### APPEAL SUMMARY

<b>Appeal ID:</b> 23427	<b>Project Address:</b> 3330 SE 69th Ave
<b>Hearing Date:</b> 2/5/20	<b>Appellant Name:</b> Tim Ayersman
<b>Case No.:</b> B-018	<b>Appellant Phone:</b> 971-200-7213
<b>Appeal Type:</b> Building	<b>Plans Examiner/Inspector:</b> John Cooley
<b>Project Type:</b> commercial	<b>Stories:</b> 3 <b>Occupancy:</b> E, B, A-2, A-3 <b>Construction Type:</b> II-B
<b>Building/Business Name:</b> Portland Public Schools - Kellogg Middle School	<b>Fire Sprinklers:</b> Yes - Fully-sprinklered throughout
<b>Appeal Involves:</b> Erection of a new structure	<b>LUR or Permit Application No.:</b> 19-130649-CO
<b>Plan Submitted Option:</b> pdf [File 1]	<b>Proposed use:</b> Middle School (Grades 6-8)

#### Appeal item 1

**Alternate 1 hour fire rated fire wall assembly with engineering analysis: Hold for additional information. Appellant may contact John Butler (503 823-7339) with questions.**

1/G-202

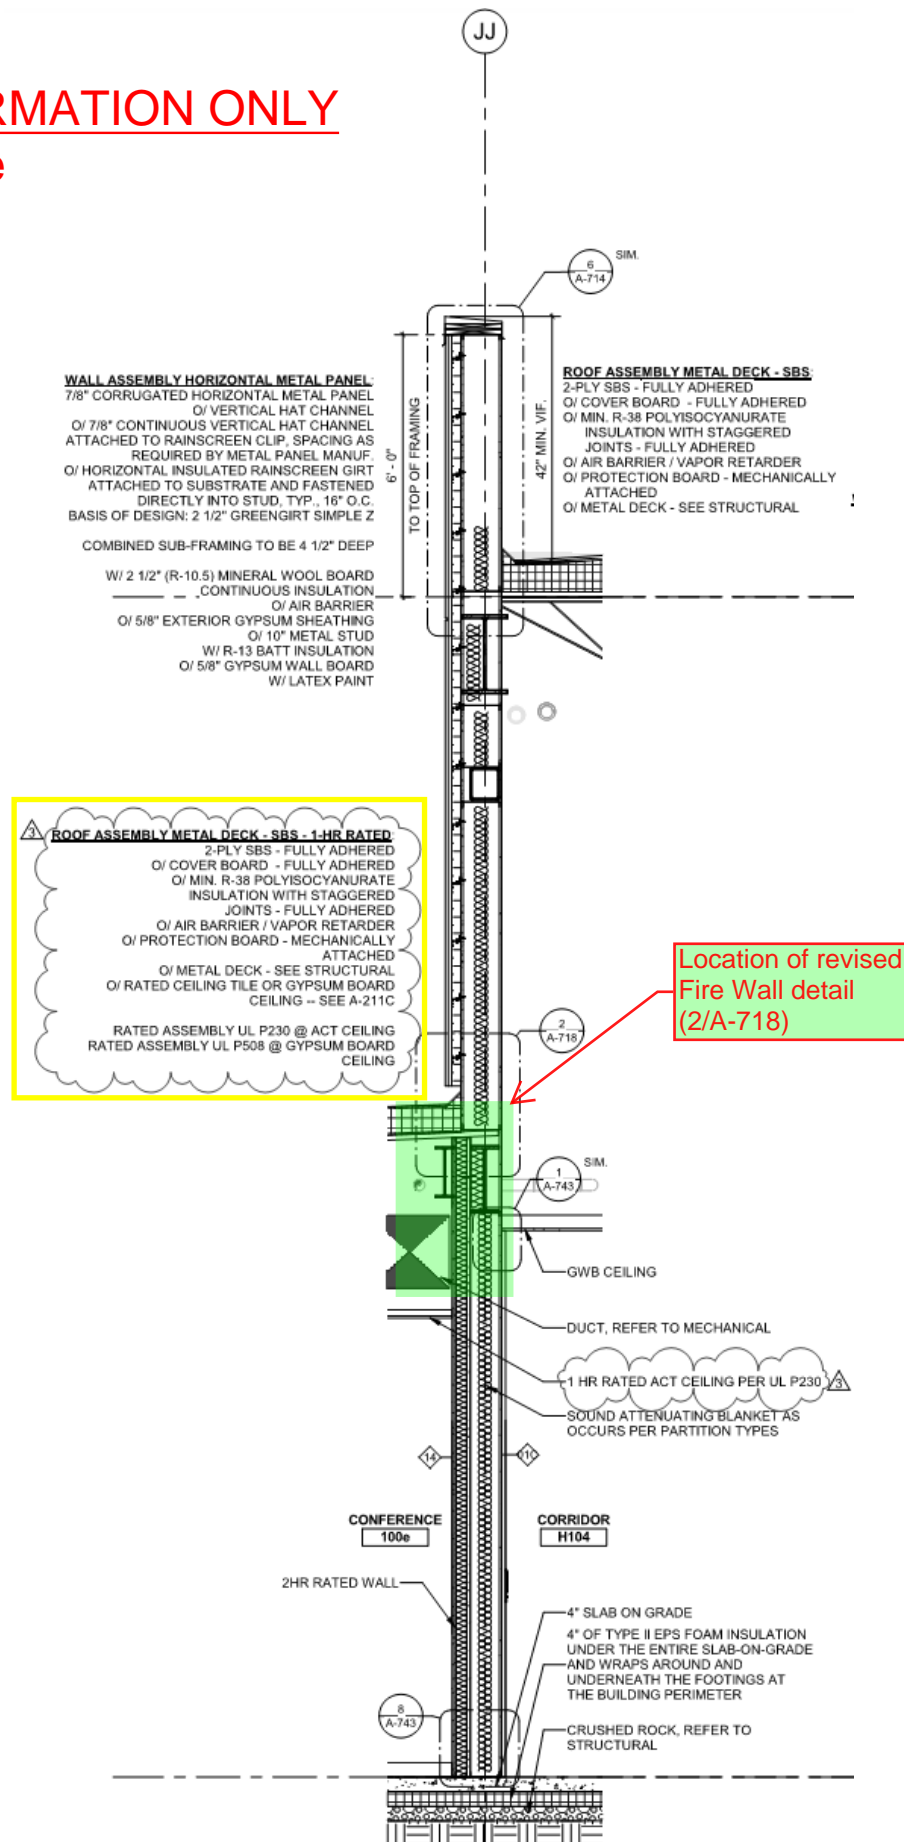
- Location of Fire Wall and appeal proposal.
- 1-hour rated roof assembly and supporting element extents.

4/A-419

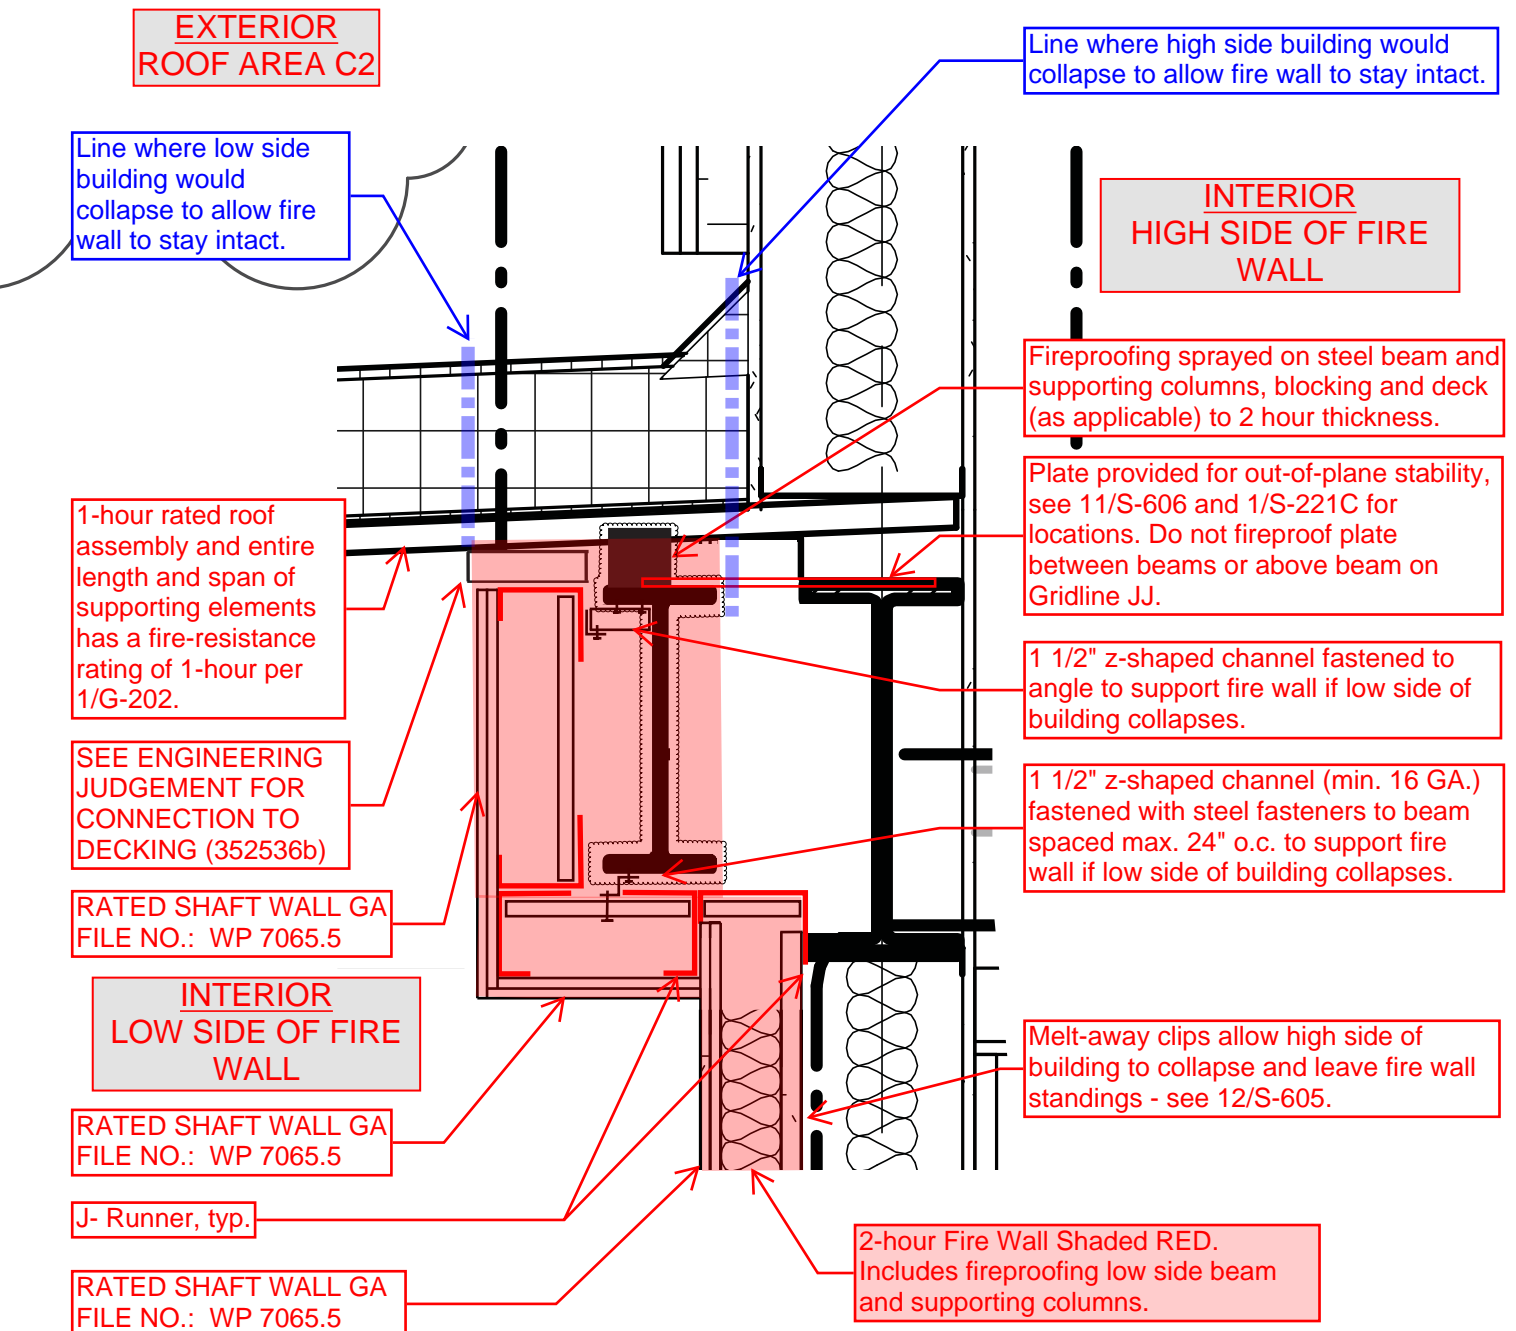
- Wall section at Fire Wall along Gridline JJ.
- Location of revised Fire Wall detail.
- Description of 1-hour rated roof assembly

2/A-718

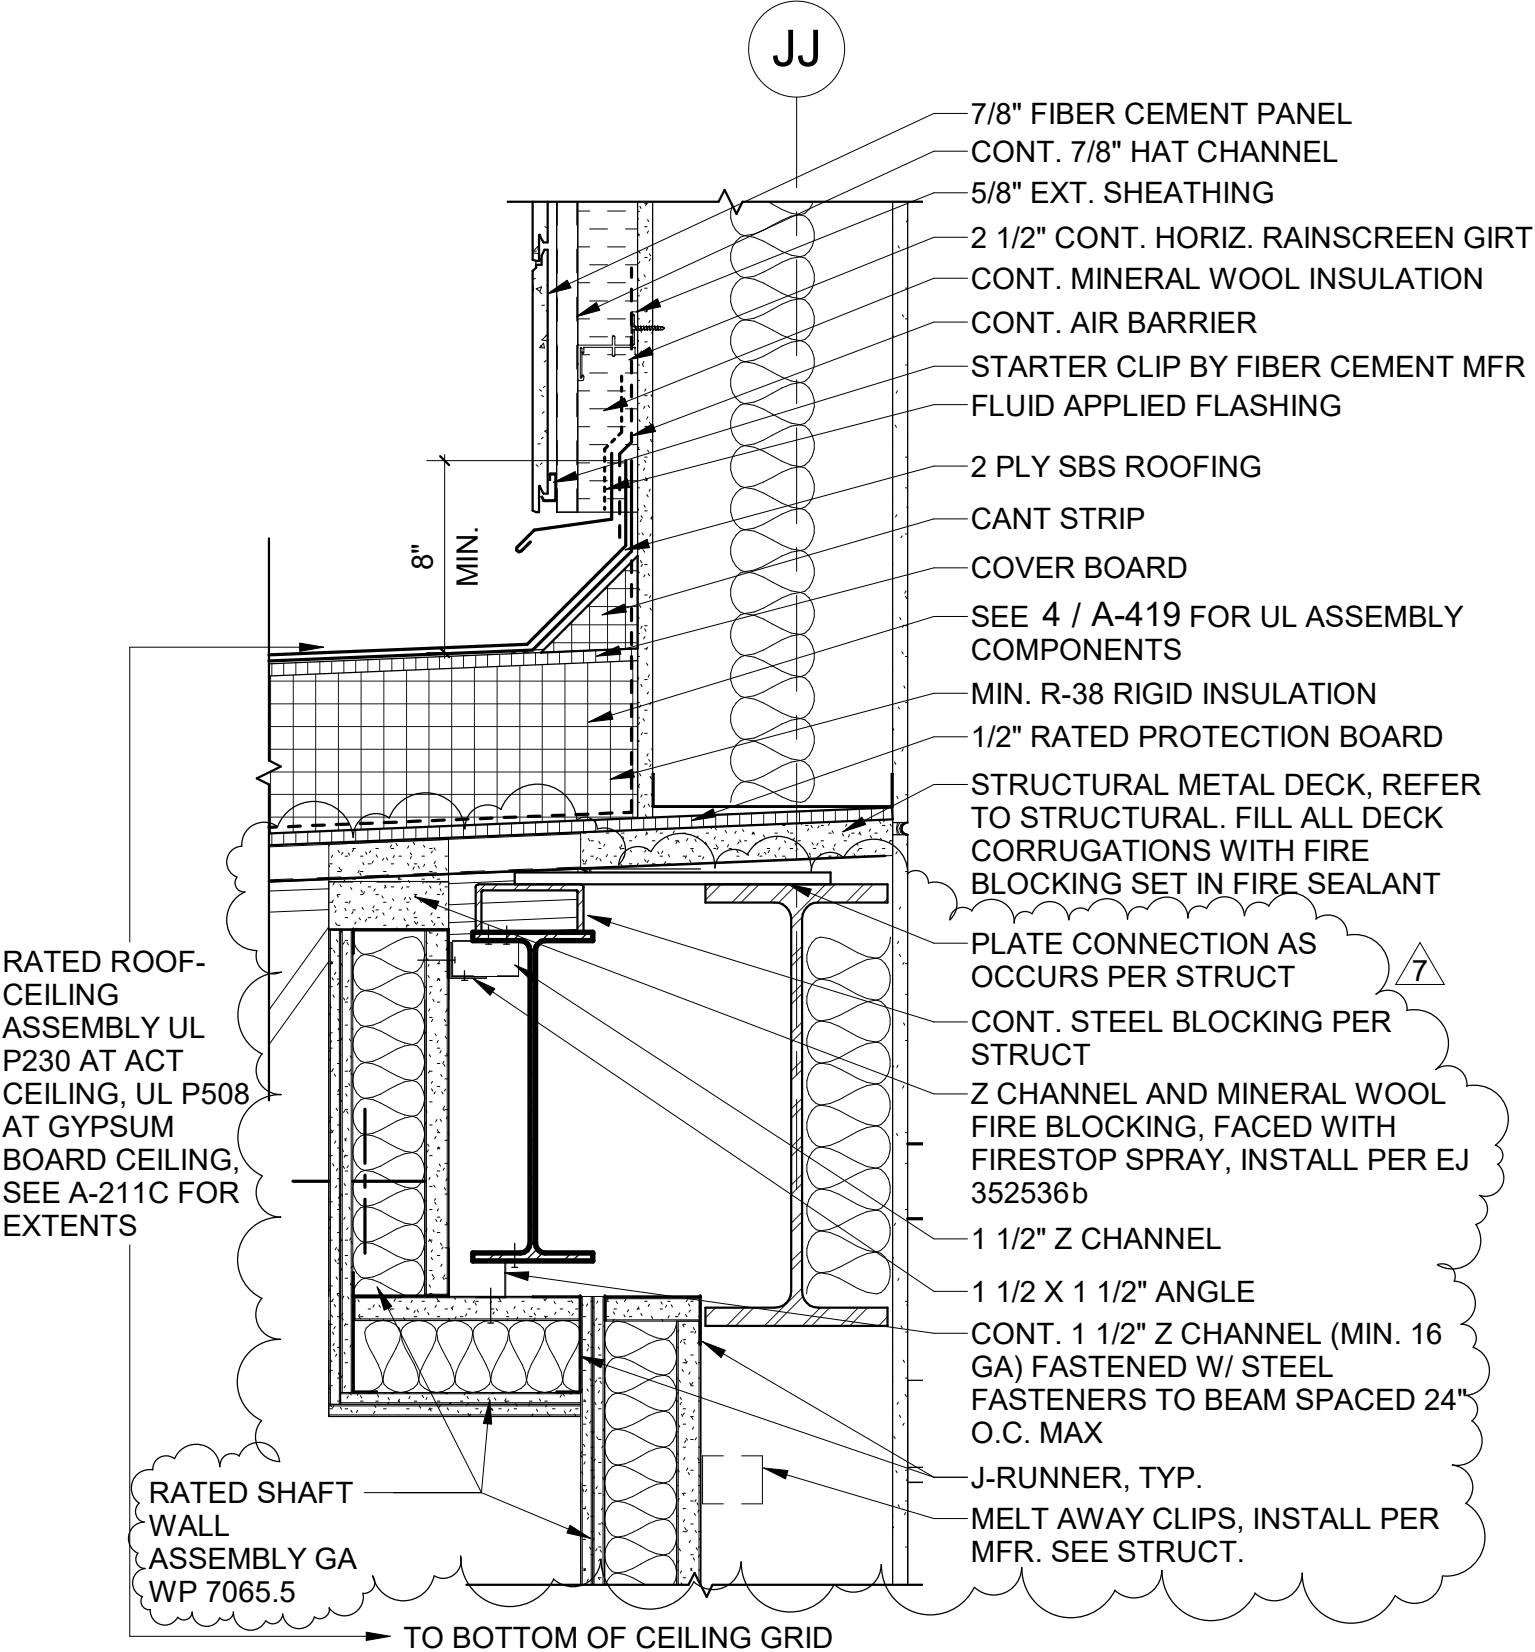
▪ Fire Wall revision overview sketch.

■ Proposed revised detail at Fire Wall

**352536b*****Saving Lives through Innovation and Education***

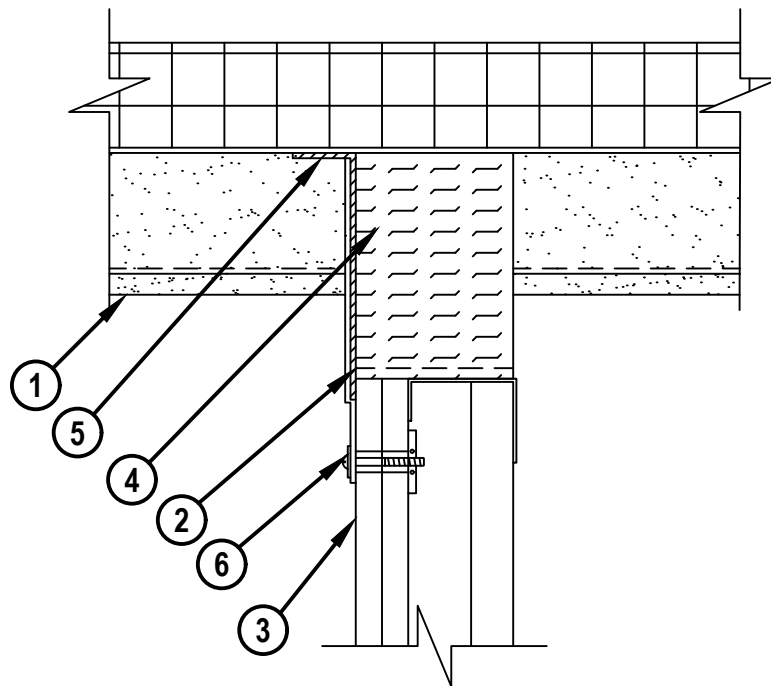
■ Fire Wall connection to deck detail.
